Service Bulletin

Subject: Information on Availability of Tri-fold Tonneau Cover New Spring Latch Kit

Brand:	Model:	Model Year:		VIN:		Engine:	Transmission:
		from	to	from	to		
Chevrolet	Colorado Silverado	2016	2018			All	All
GMC	Canyon Sierra

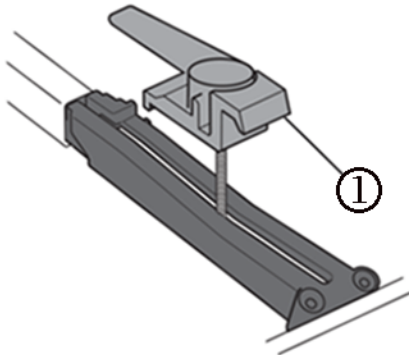
Involved Region or Country	North America, Middle East, Israel, Thailand, Chile
Condition	 <p>Some customers may comment that the tri-fold tonneau cover original quarter turn latch (1) will not turn nor stay latched.</p>
Cause	The cause of the condition may be a broken quarter turn latch.

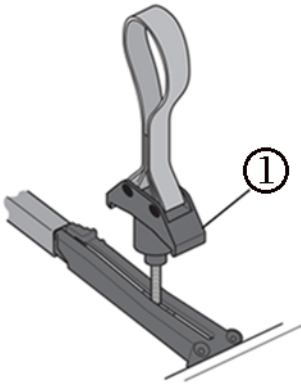
<p>Correction</p>	<div style="text-align: center;">  </div> <p>Replace both original quarter turn tonneau latches with new design spring latches (1) from the appropriate parts kit listed in the Parts table.</p>
--------------------------	--
